FINAL PHASE III RFI/RI WORK PLAN

REVISION 1

ROCKY FLATS PLANT

881 HILLSIDE AREA

FIGURE 1-3

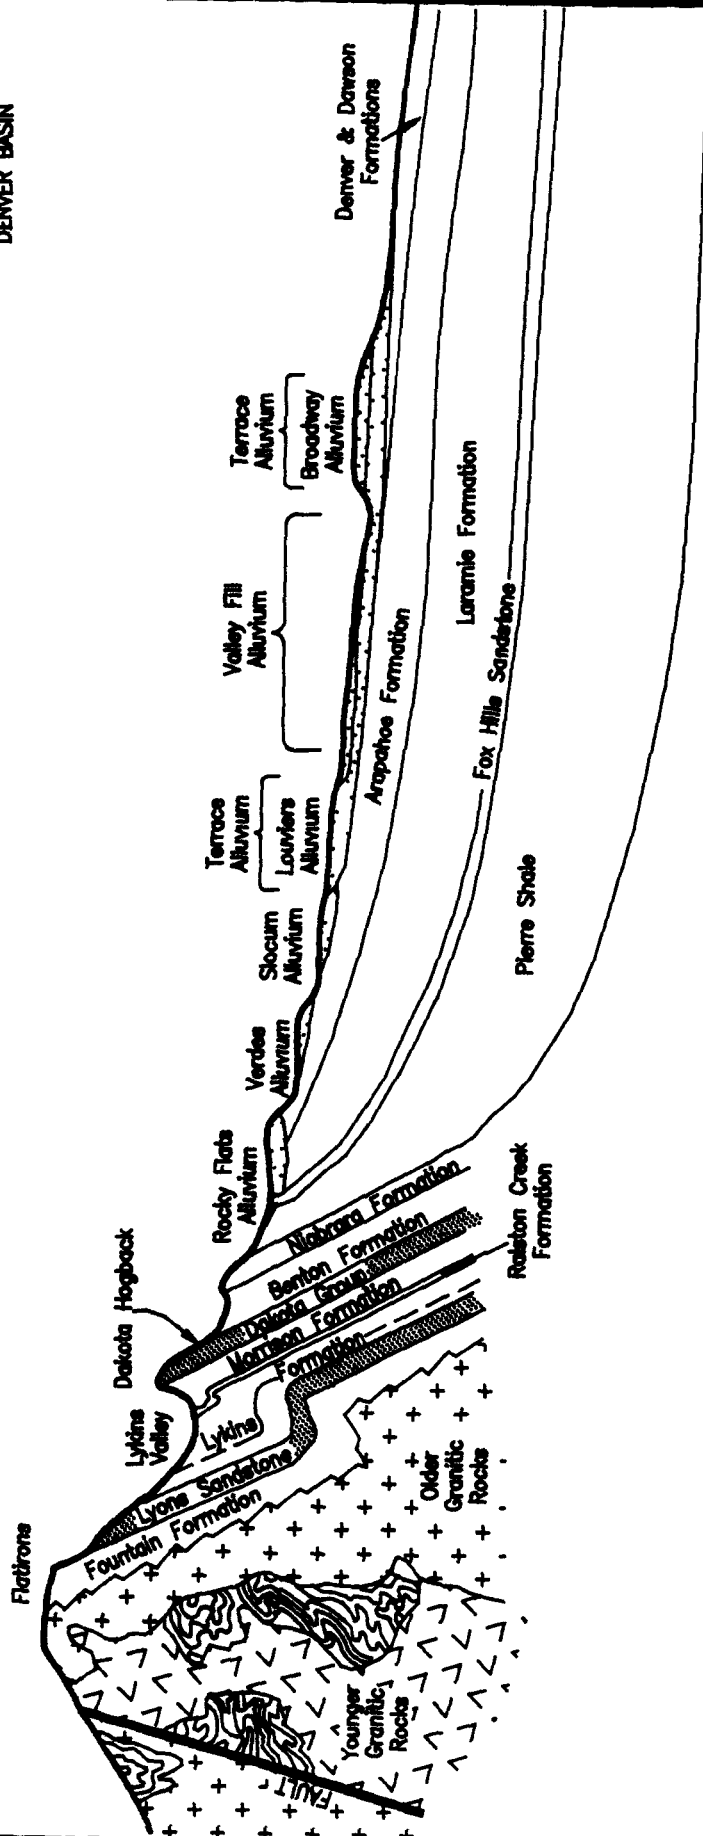
The extent of the Rocky Flats Alluvium should have been shown (refer to figure 2-2) A cross section should have been added that illustrates eastward thinning of the Rocky Flats Alluvium

Figure 1-3 in Revision 1 of the Final Phase III RFI/RI Work Plan, presents a simplified east-west cross section of the "surficial alluvial deposits" and illustrates the limited extent of the Rocky Flats Alluvium Figure 2-3 presents the extent of the Rocky Flats Alluvium in the vicinity of the 881 Hillside

FIGURE 2-3

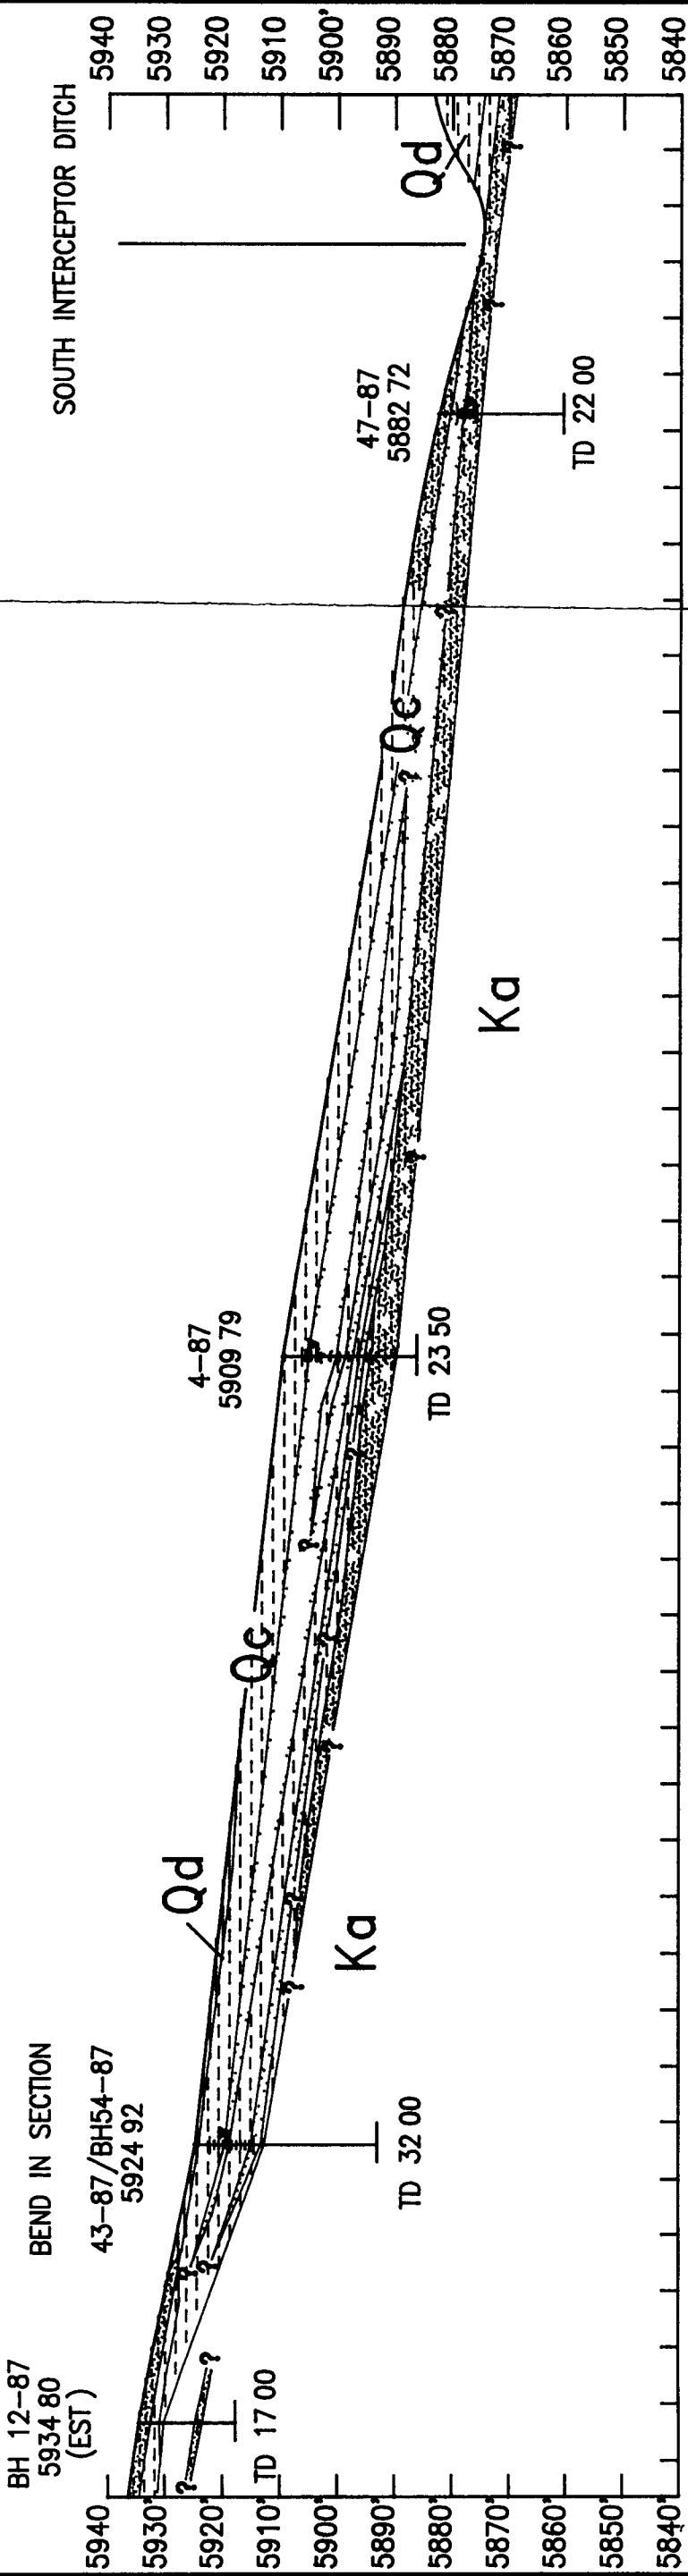
Figure 2-2

All of IHSS 119.2 has been shown as disturbed ground in Figure 2-3 (formerly Figure 2-2) in Revision 1 of the Final Phase III RFI/RI Work Plan.

FIGURE 2-20

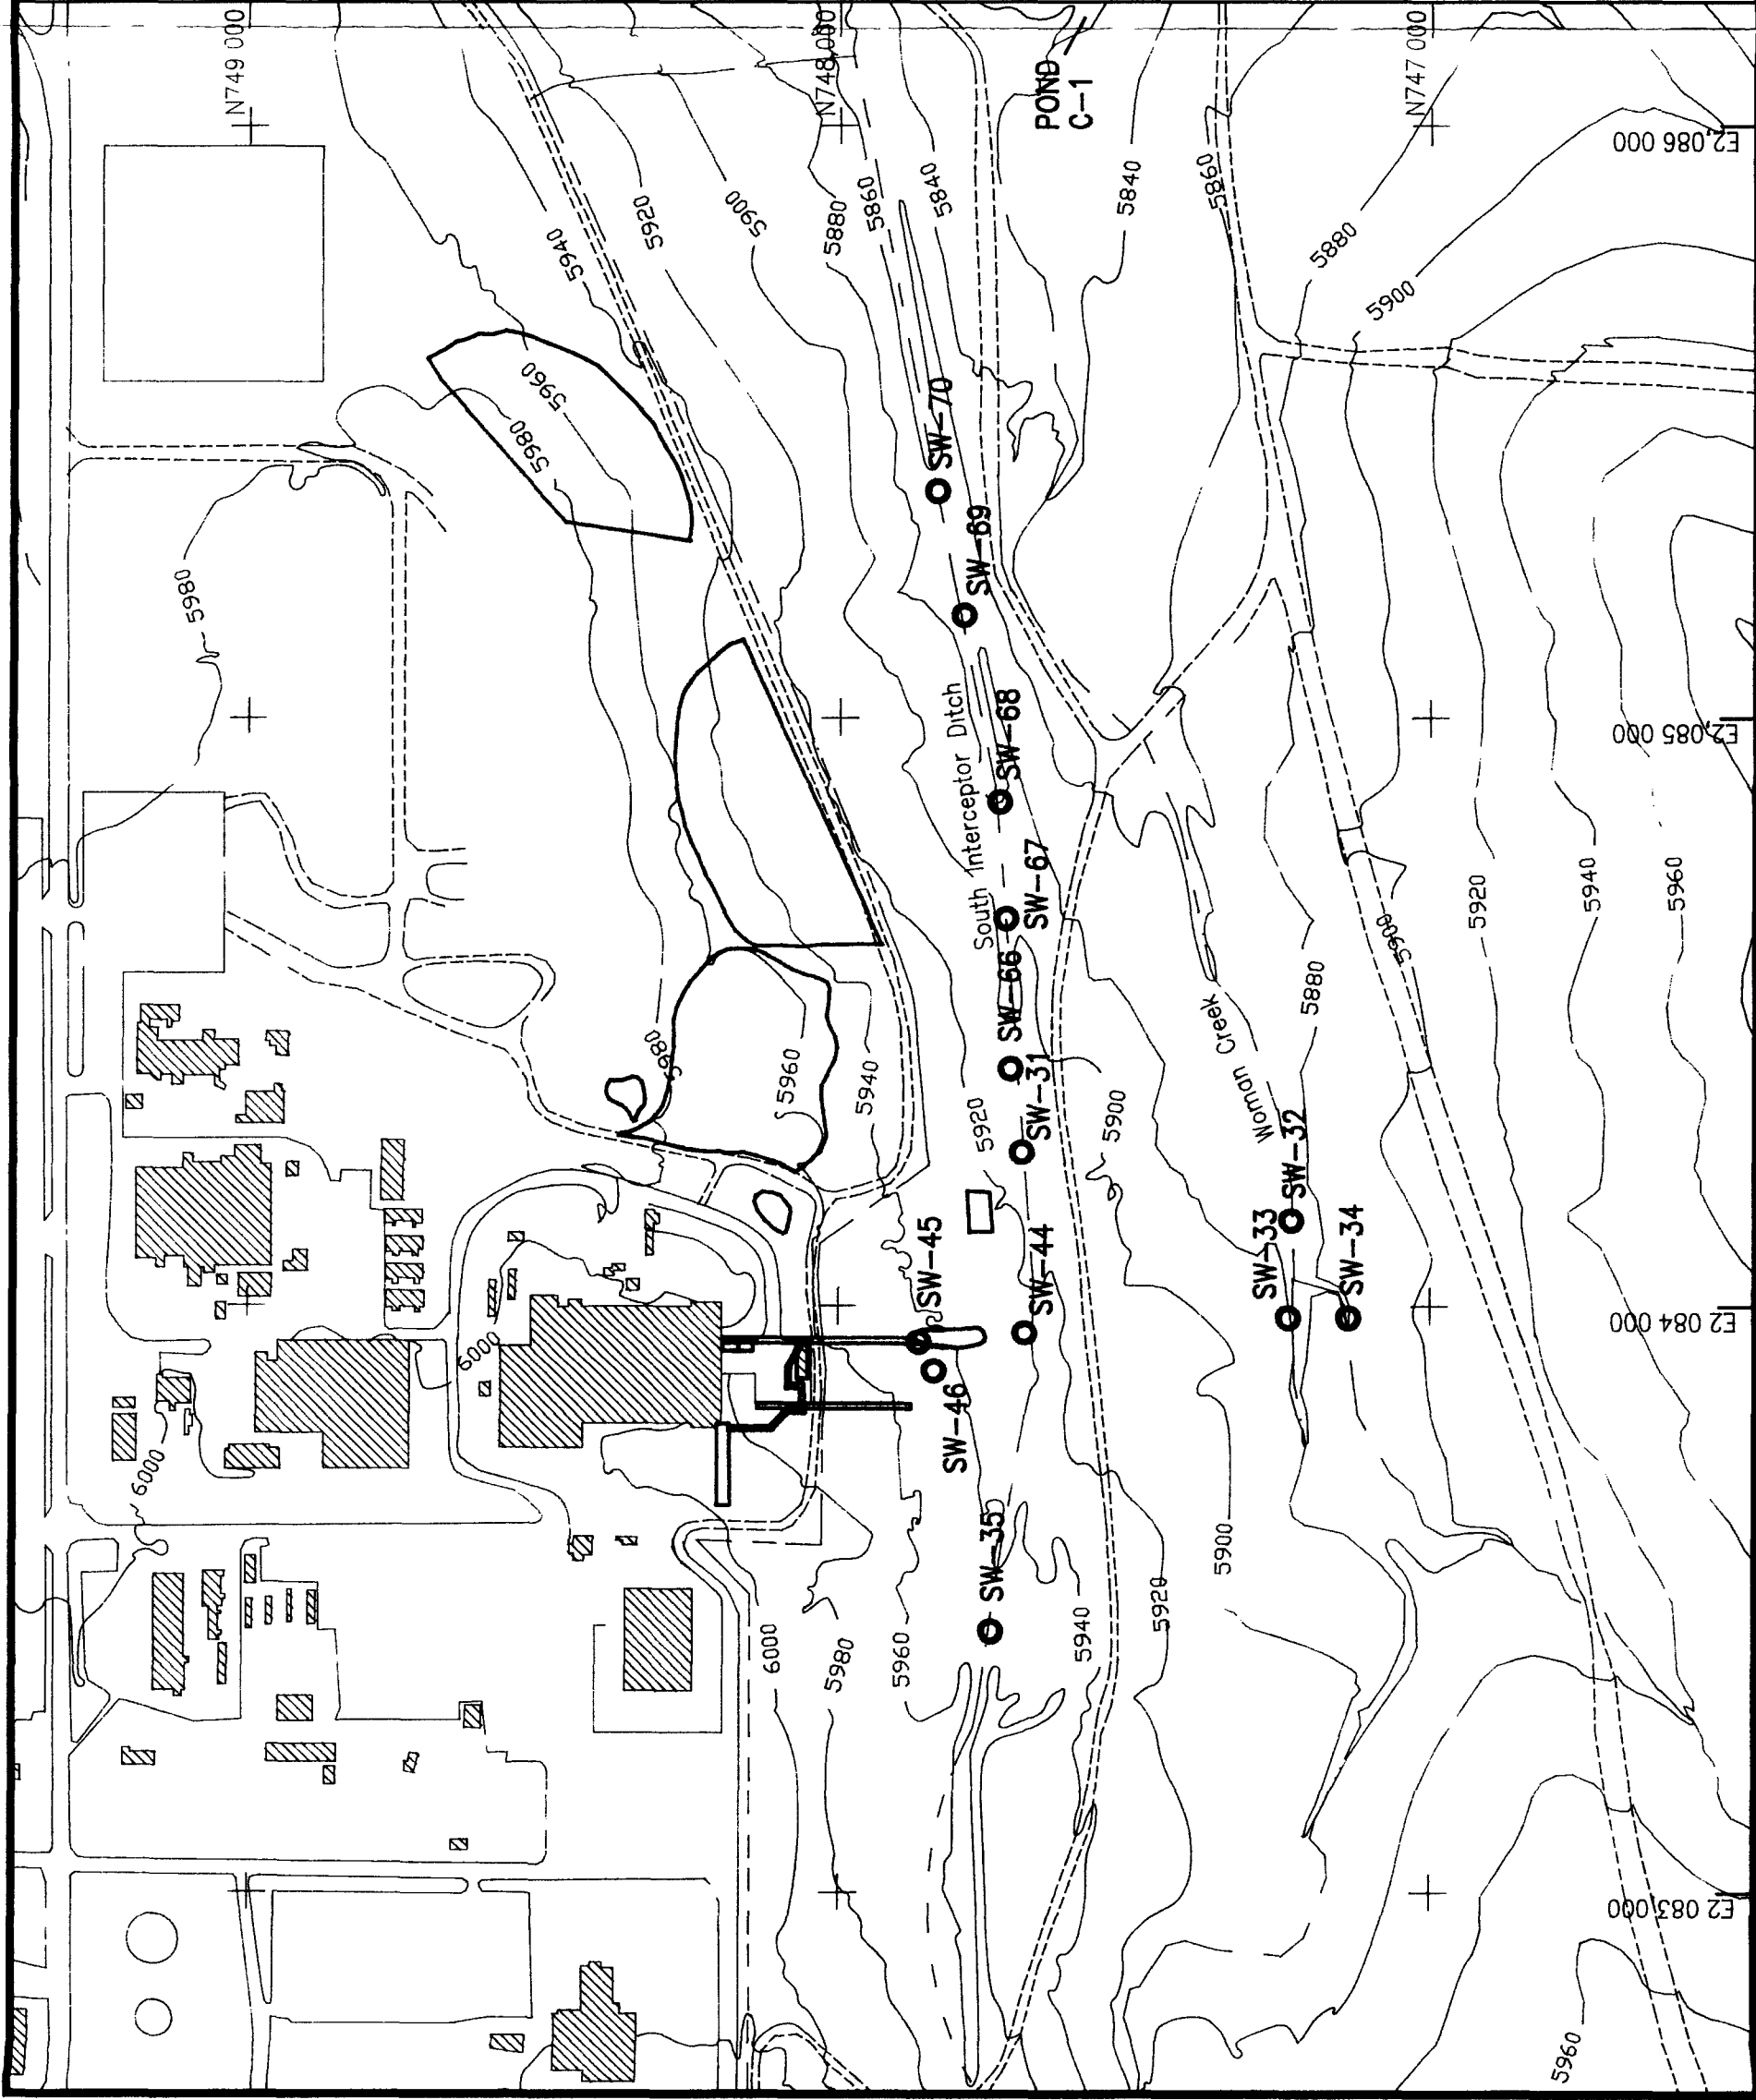
The sample locations should have been shown on a map. Figure 2-17 does not show the sediment sampling locations (see also response to EPA and CDH comments). The sampling locations must be presented in the Phase III RFI/RI Report. Results of sediment sampling should have been compared with surface water, groundwater and soil sampling results. This must be done in the Phase III RFI/RI Report. The question arises once again about whether the low levels of certain volatile organic compounds in the samples represent contamination especially if present in blanks. Until it can be demonstrated that the presence of these contaminants is due to lab contamination, they should be considered present. Additionally, not all the volatiles sampled for were in low concentrations.

The surface water and sediment sampling locations are presented on Figures 2-20 and 2-21, respectively, in the revised Phase III RFI/RI Work Plan. The results of sediment sampling will be compared with other media in the Phase III RFI/RI Report. Chloromethane, acetone, chloroform, and TCE will be considered as possible contaminants, and further investigation is needed to determine if these constituents are site contaminants or laboratory artifacts. Section 2.3.3.3 states that for the purposes of defining the field sampling plan all constituents above background are considered representative of contamination.
